In the matter of
Wabash Mine Holding Company
Wabash Mine
I.D. No. 11-00877

Petition for Modification

Docket No. M-2005-030-C

PROPOSED DECISION AND ORDER

Exhibit B

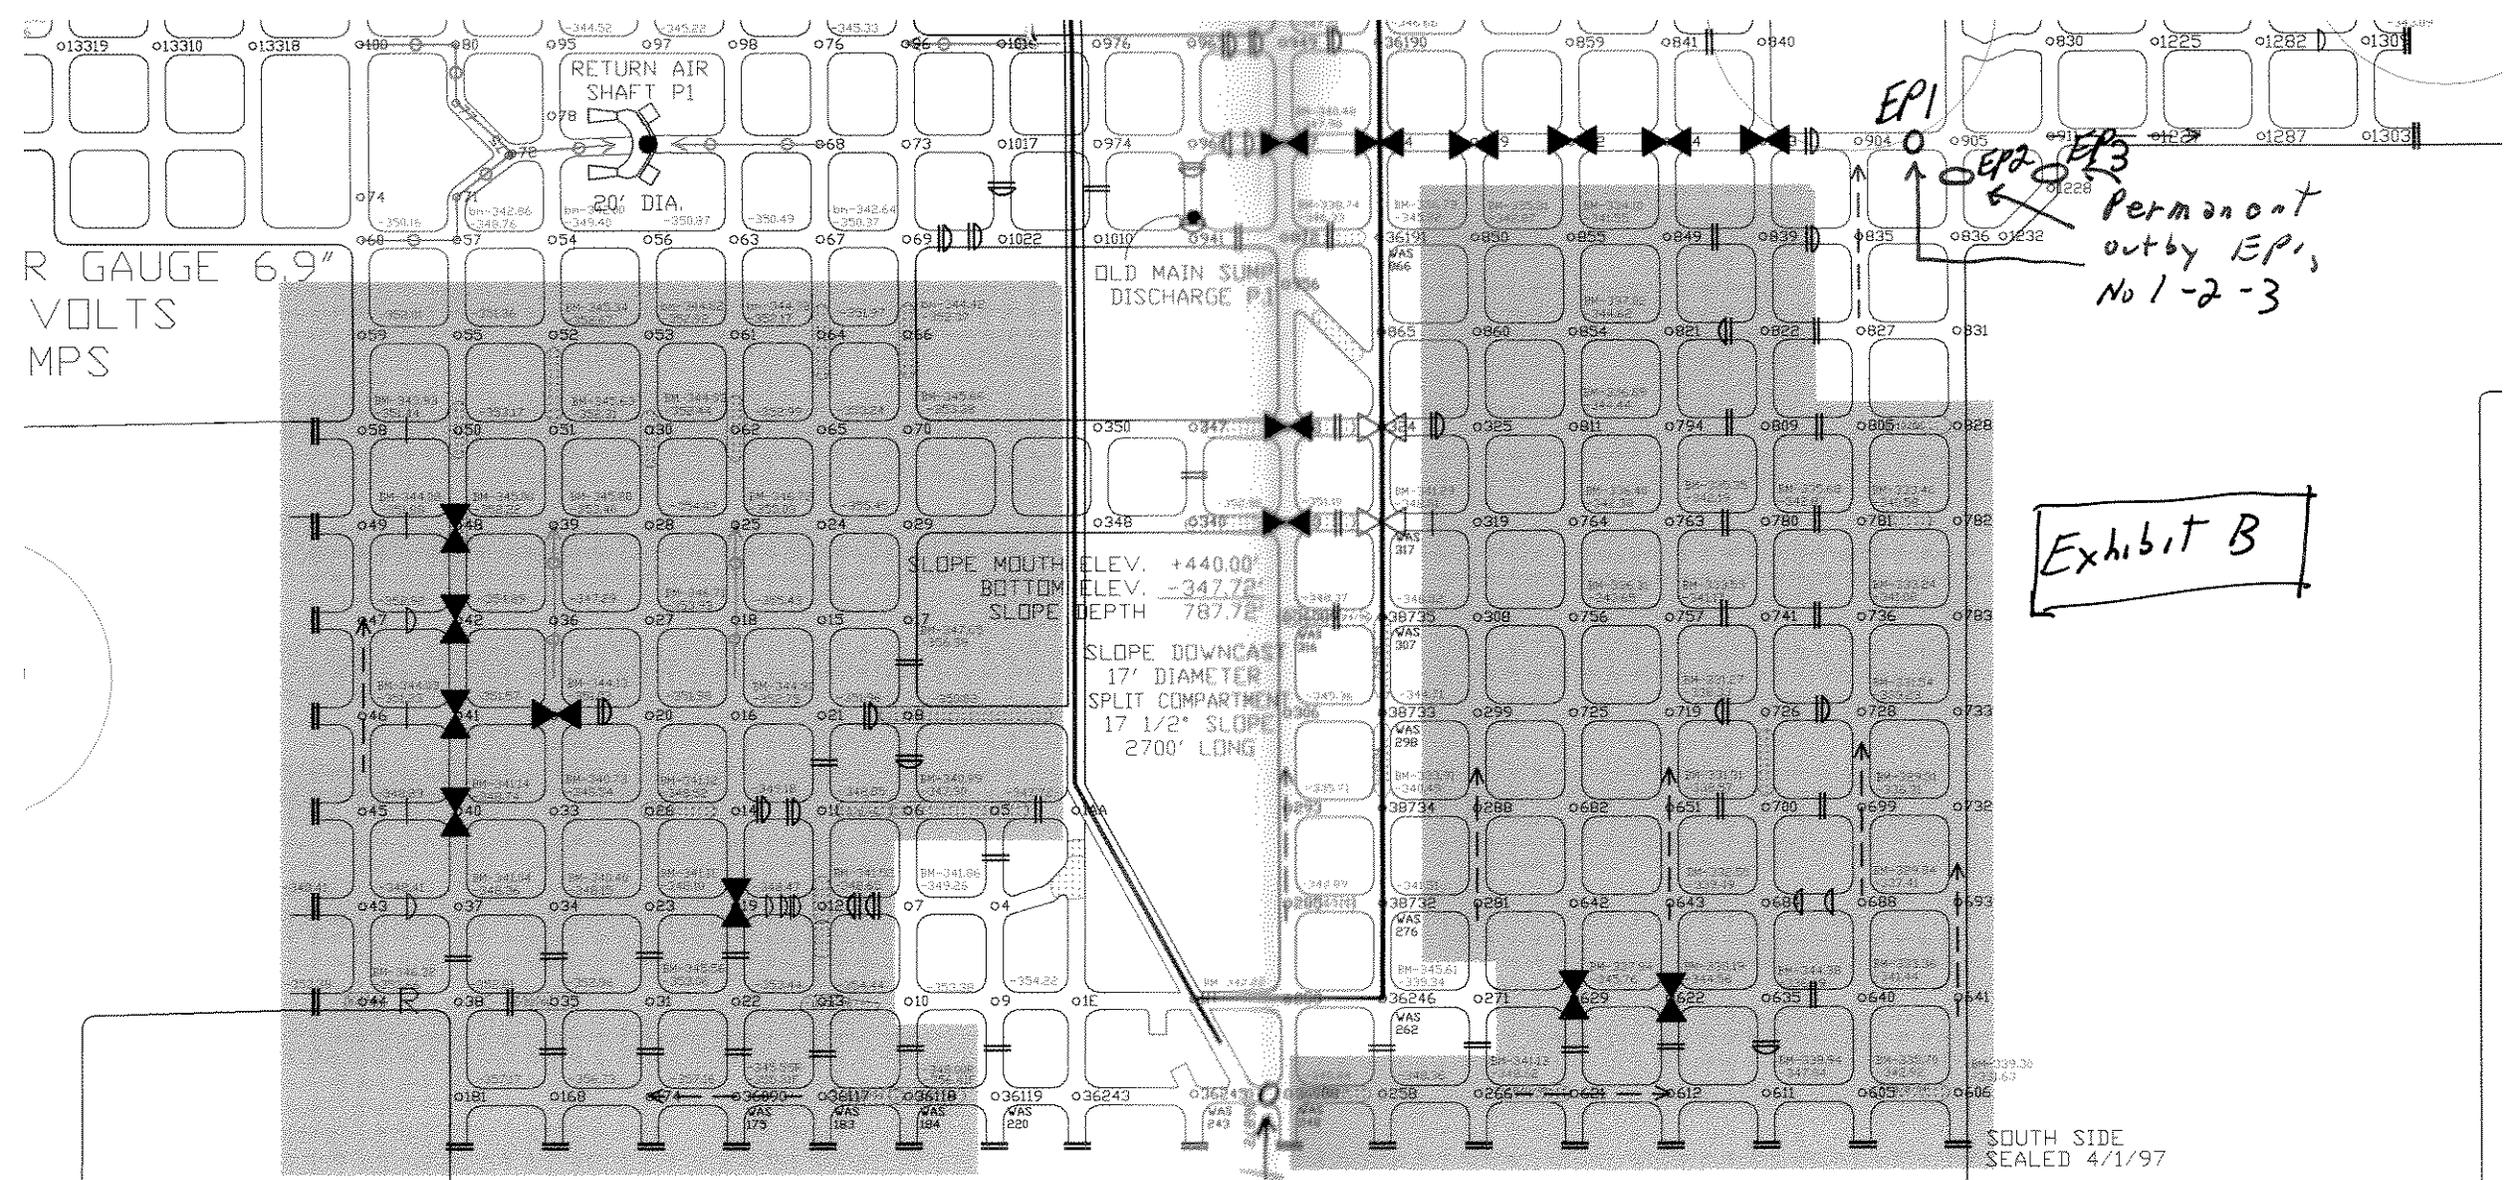
- a. The Intake EP monitoring station shall be located where air enters the inaccessible area, near the No. 8 Main South Seal and the slope bottom at the Intake EP as designated on the attached map.

- b. The Permanent Outby EP shall consist of three monitoring stations, located where air leaves the inaccessible area, near the Main East Seal No. 10 at Permanent Outby EPs No. 1, No. 2, and No. 3 as designated on the attached map labeled Exhibit B.

- c. A monitor connected to the mine-wide monitoring system must be located at the Permanent Outby EPs No. 1, No. 2, and No. 3, in the airflow on the downwind side of the sealed area as shown on Exhibit B; and must continuously monitor for methane and oxygen with alert levels at 1% methane and alarm levels at 1.5% methane and 19.5% oxygen.
